Haweswater Aqueduct Resilience Programme - Proposed Bowland Section

Supplementary Environmental Information Report

Project No: B27070CT
Document Title: Proposed Bowland Section
Supplementary Environmental Information Report
Document Ref.: LCC_RVBC-BO_SEI
Revision: 0
Date: February 2022
Client Name: United Utilities Water Ltd

SCALE 1:25,000	SHEET SIZE A3
DRAWING NUMBER LCC_RVBC-BO-FIG-003-001B	REVISION 1

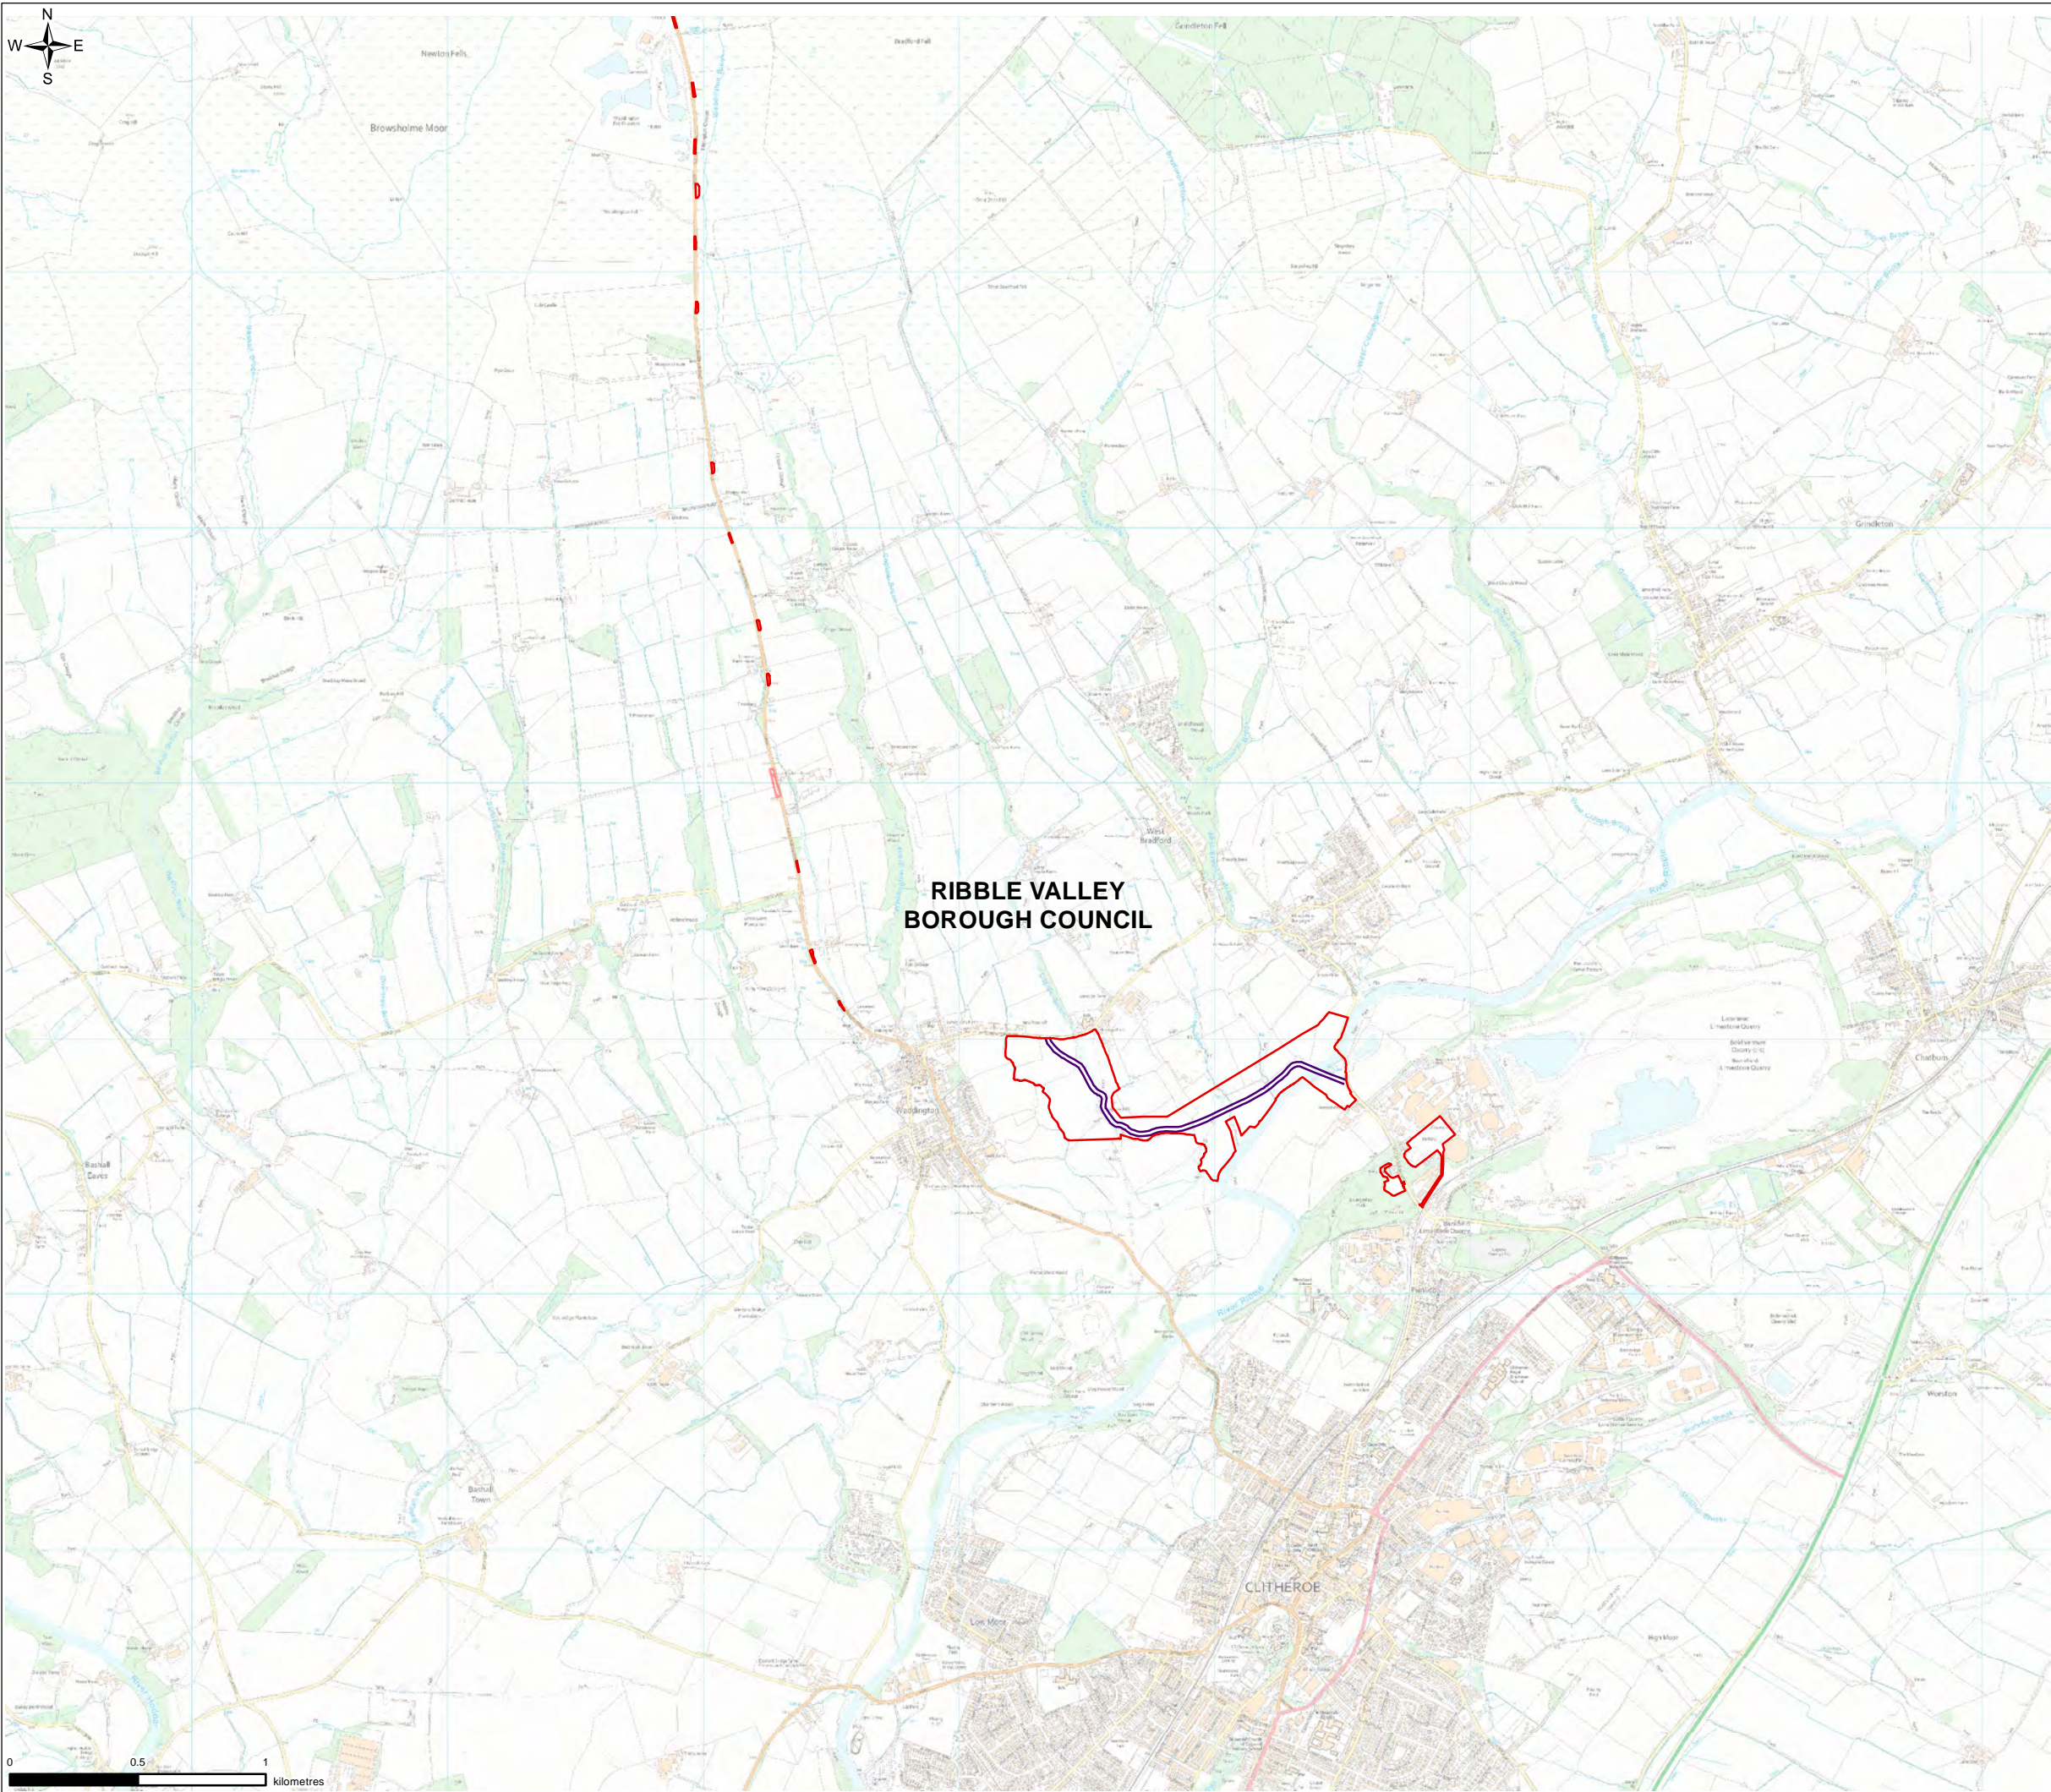
- 28) Figures 3.1a and 3.1b present the updated planning application boundaries for the Proposed Bowland Section; more detailed and larger scale drawings are provided in the February 2022 Revised Planning Application documents. Figure 3.1a focuses on the main construction compounds and the route of the tunnel below ground level. Figure 3.1b shows all the elements of the Proposed Bowland Section at a smaller scale, including satellite compounds and off-site highways works.
- 29) A screening exercise has been undertaken to identify where likely significant effects may arise in relation to the changes and new proposals. This has involved testing the proposed changes against each EIA topic to establish whether any likely significant effect may arise. The outcomes are summarised in Table 6.

SEI FIGURE 1

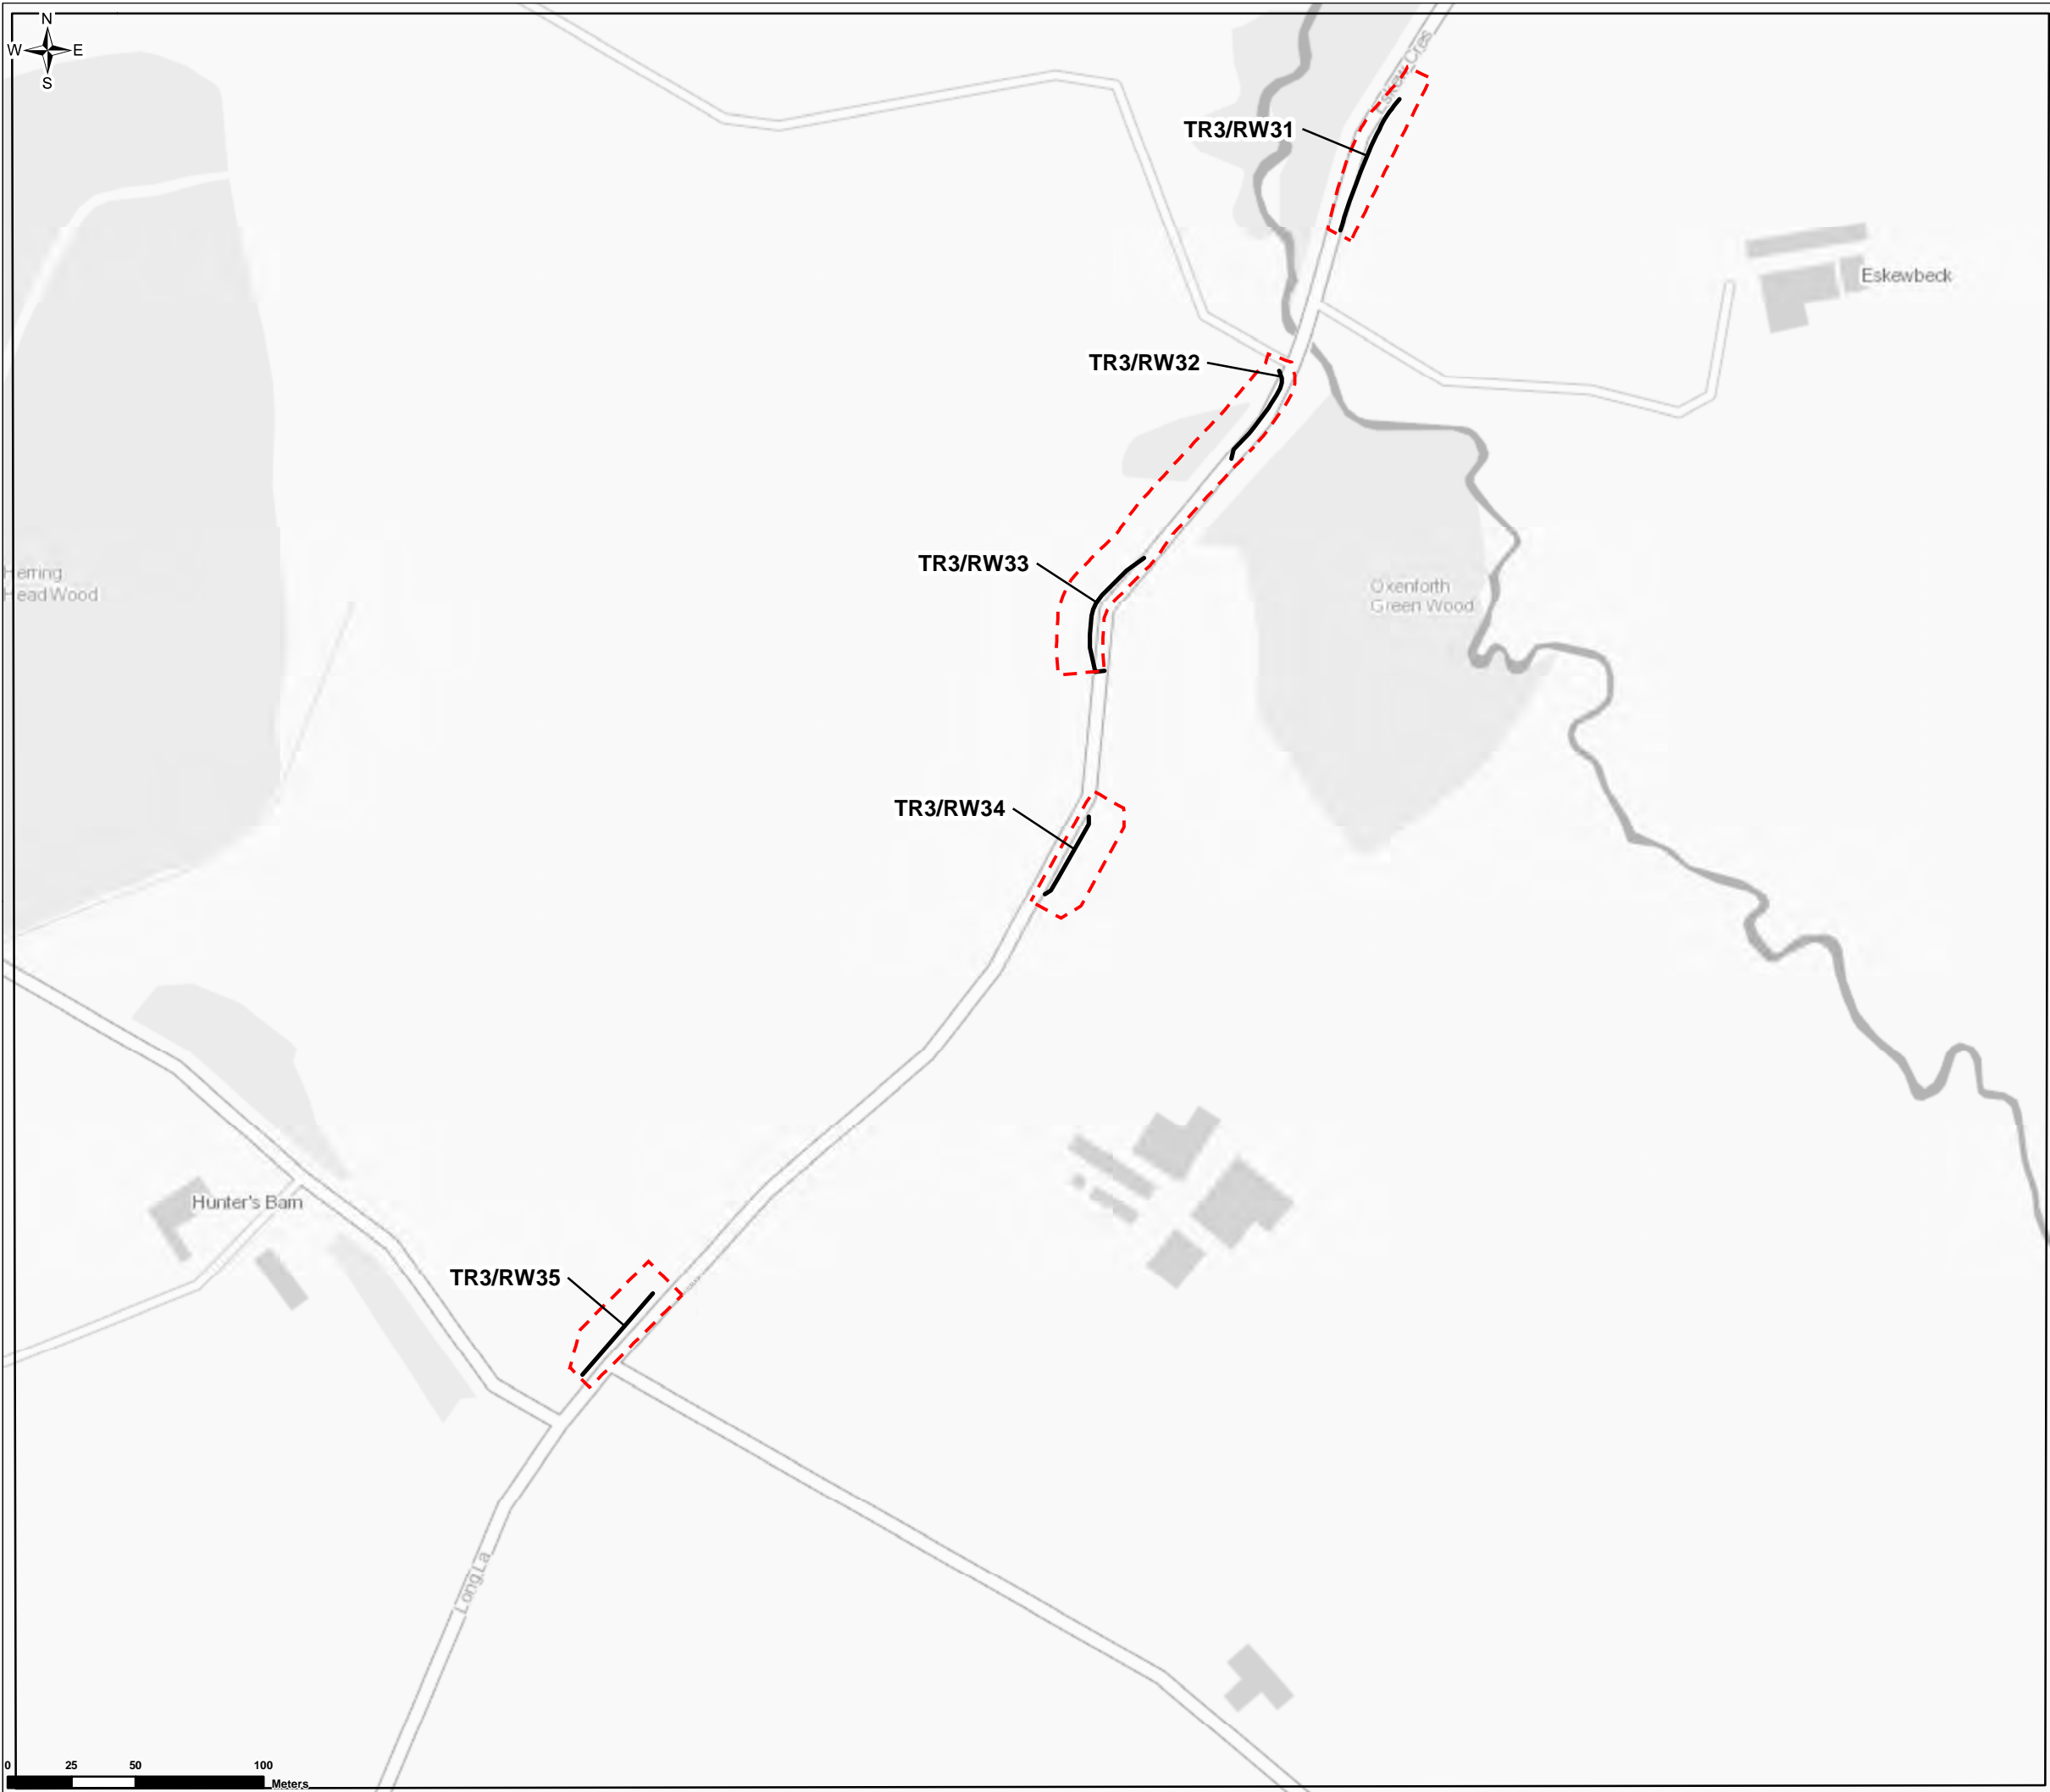
- 32) SEI Report Figure 1 shows the proposed additional planning application boundaries associated with the Lower Houses off-site highways works. Eight³ additional road widening locations (RW31-RW38) have been included along the Eskew Lane – Long Lane – Fairheath sections of road between the B6480 and Spen Brow. This is to ensure that vehicles approaching each other can pass. In addition, two laybys are proposed on Spen Brow at the top of Furnessford Road which would allow vehicles to wait whilst the onward section of road to Lower Houses Compound is made clear of vehicles travelling in the opposite direction.

³ RW32 and RW33 are combined into a single planning application boundary. As a consequence, SEI Report Figure 1 shows seven rather than eight planning application boundaries.
